ABBREVIATED PLAT AGENDA

August 6, 2025

STAFF REVIEW AND RECOMMENDATIONS
PUBLIC HEARING
AUGUST 6, 2025

ABBREVIATED PLAT: MORGAN COURT
LEGAL DESCRIPTION: SEC 10, T17N, R02W S.M., AK
PETITIONERS: THOMAS SMITH, RONDA SMITH
SURVEYOR/ENGINEER: LAVENDER / FROSTED GROUND ENGINEERING
ACRES: 4.97 +/- PARCELS: 3
REVIEWED BY: CHRIS CURLIN CASE #: 2025-97

PALMER, ALASKA
VERDA CROWTHER L2
SITE PLAN - EXISTING CONDITIONS
PROJECT OVERVIEW

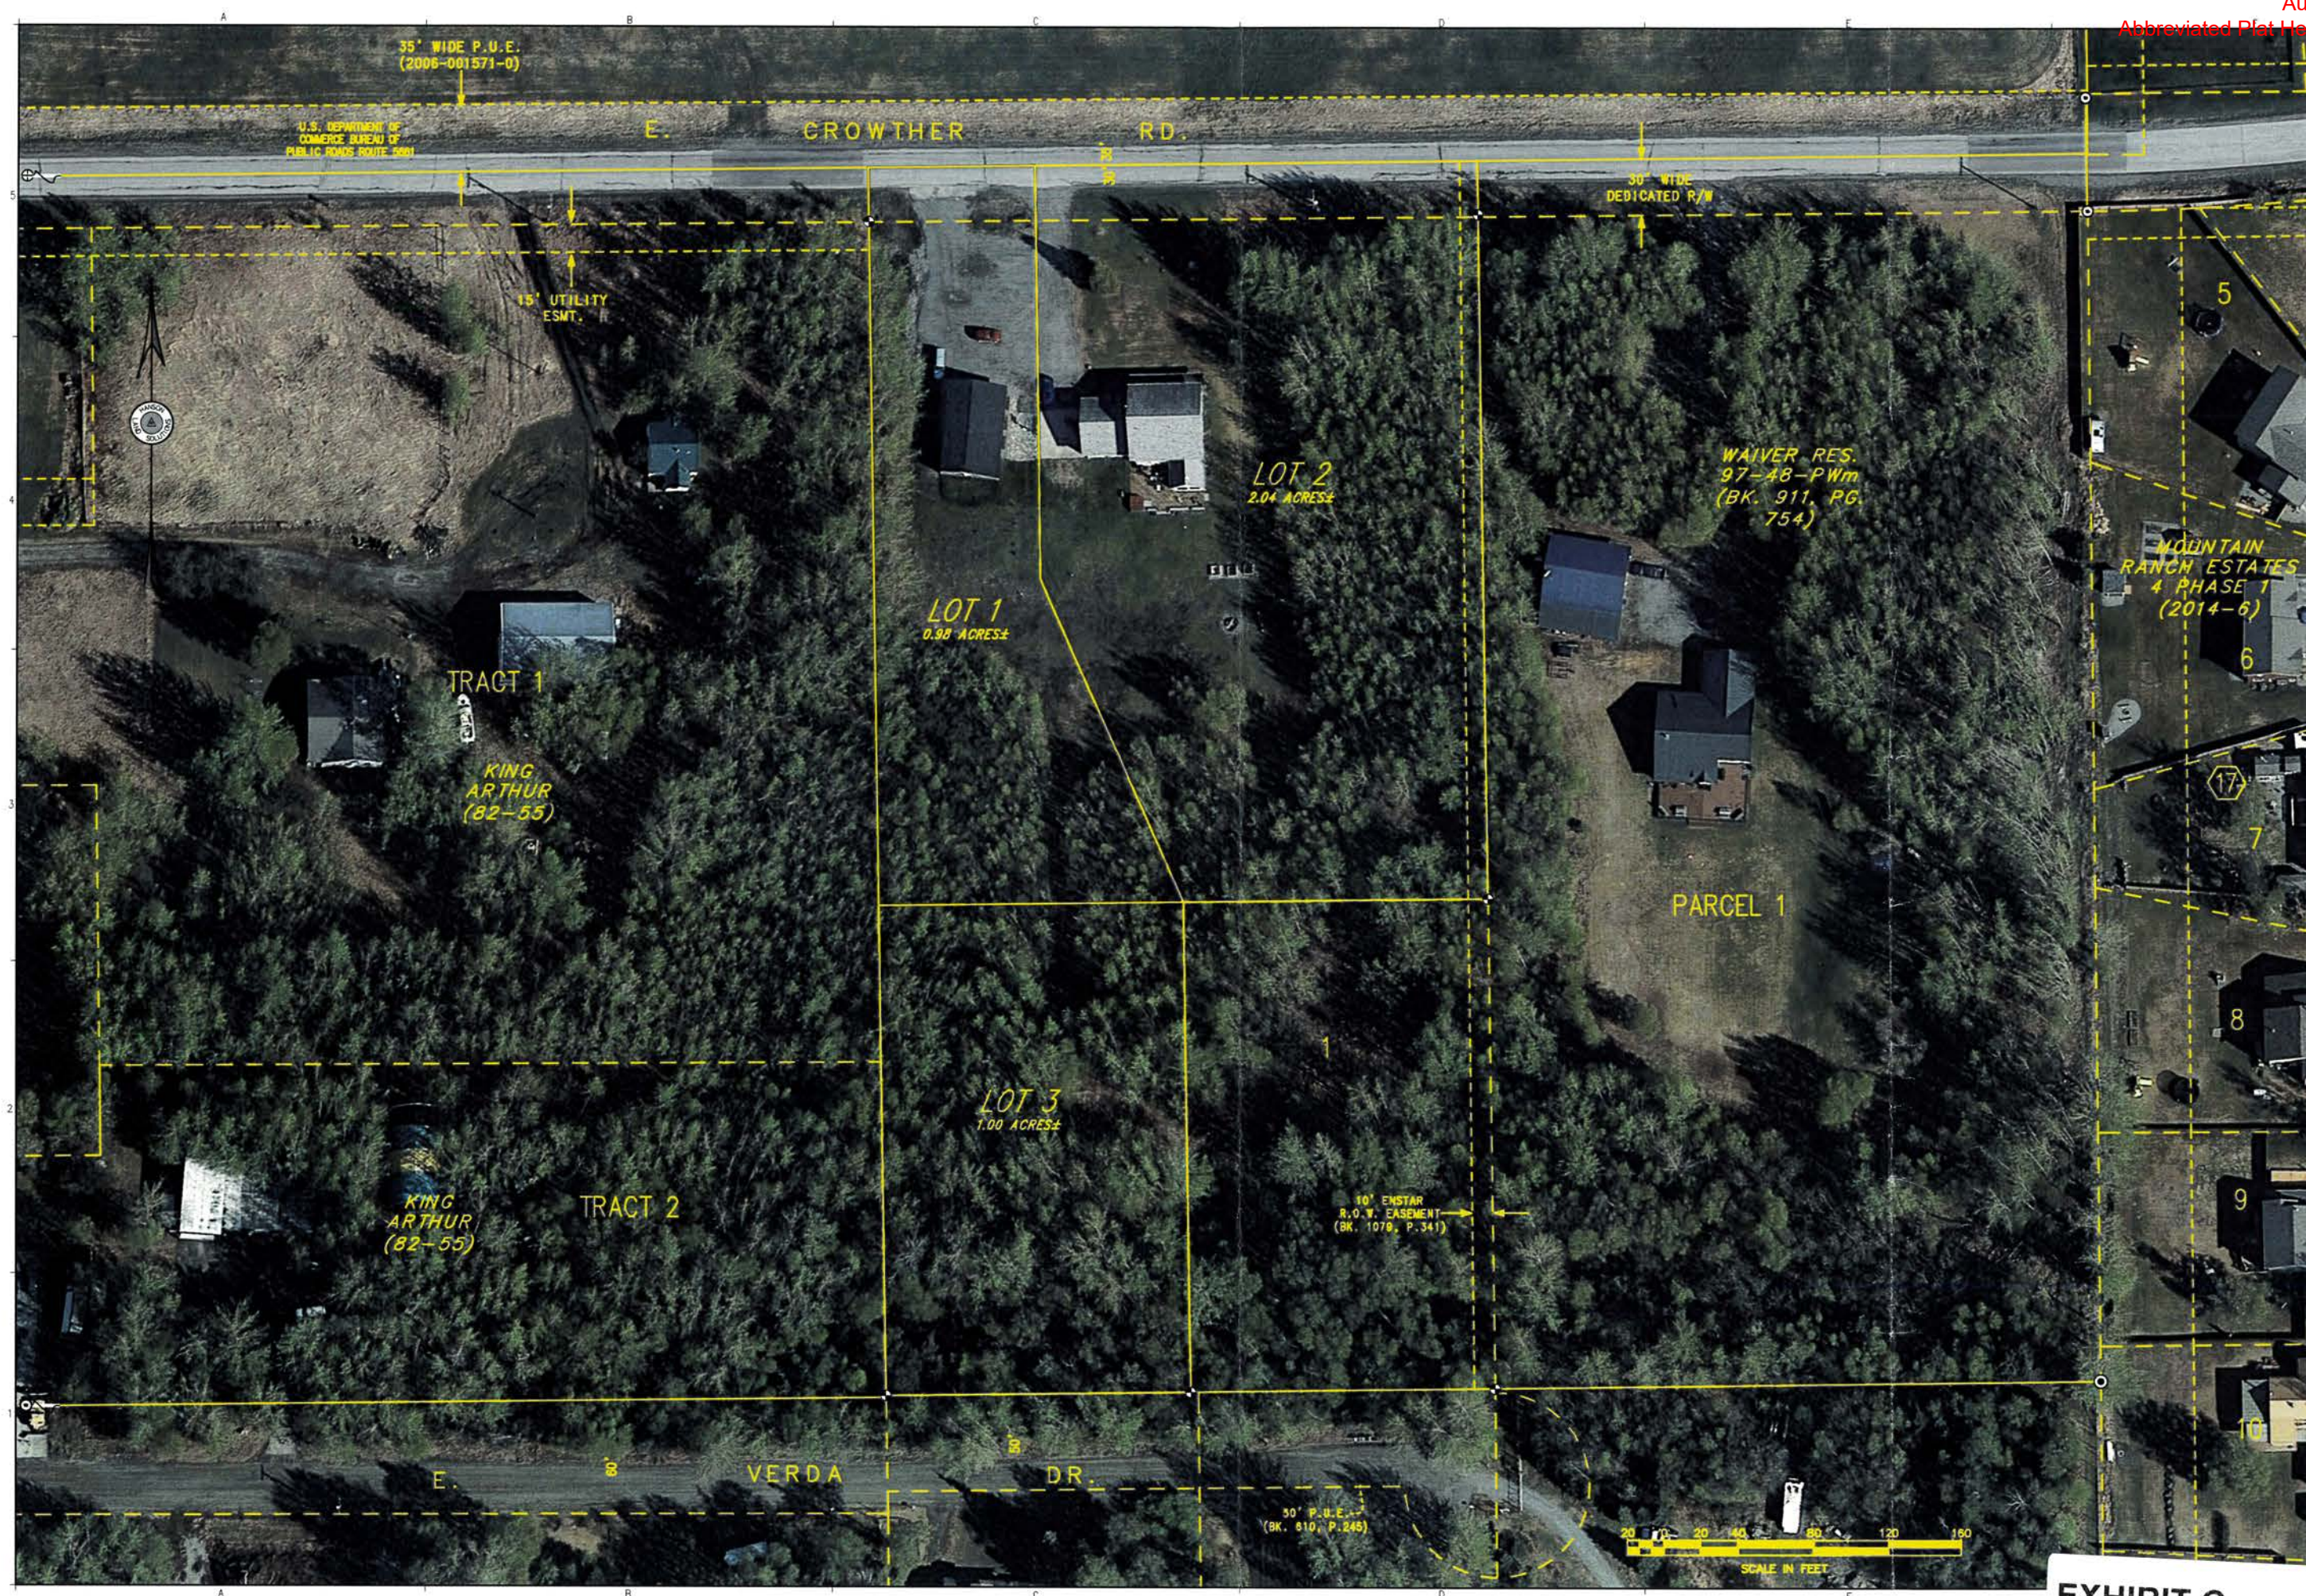
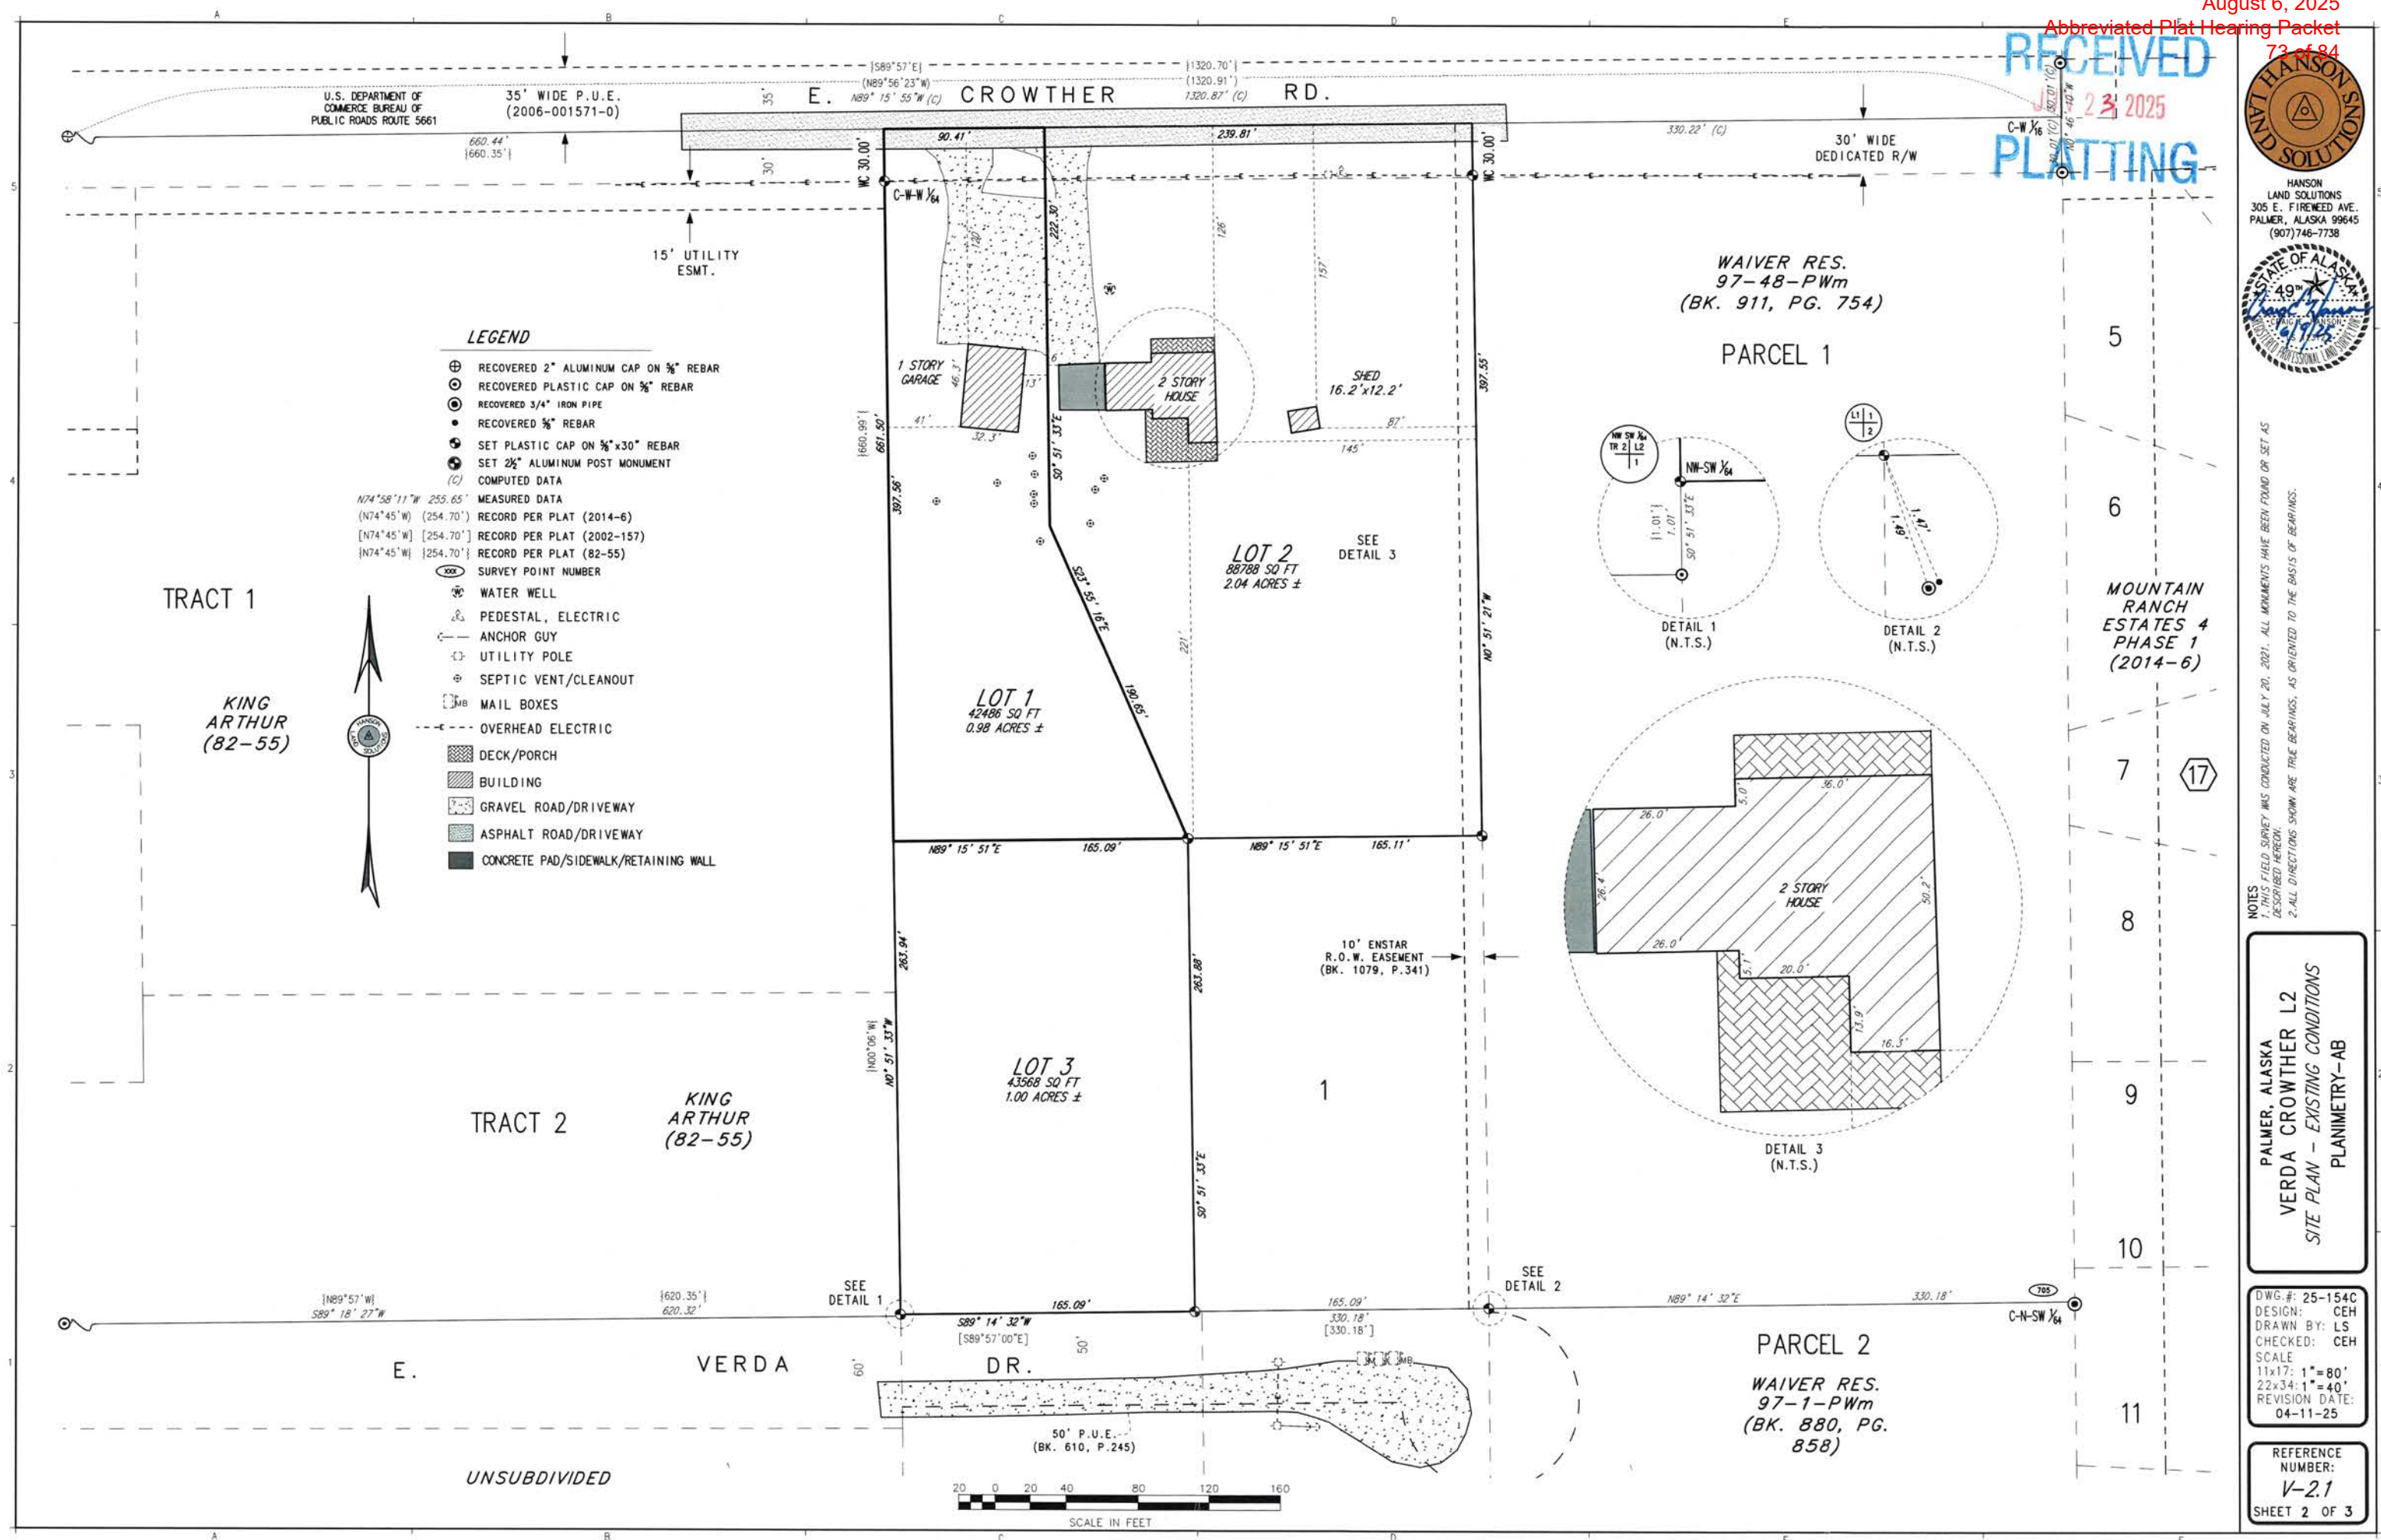
Concrete pad called out on the Site Plan is allowed to be within the proposed lot line and within the 10ft setback requirement as long as it is less than 18 inches above grade (MSB 17.55.004(A) definition of "structure".
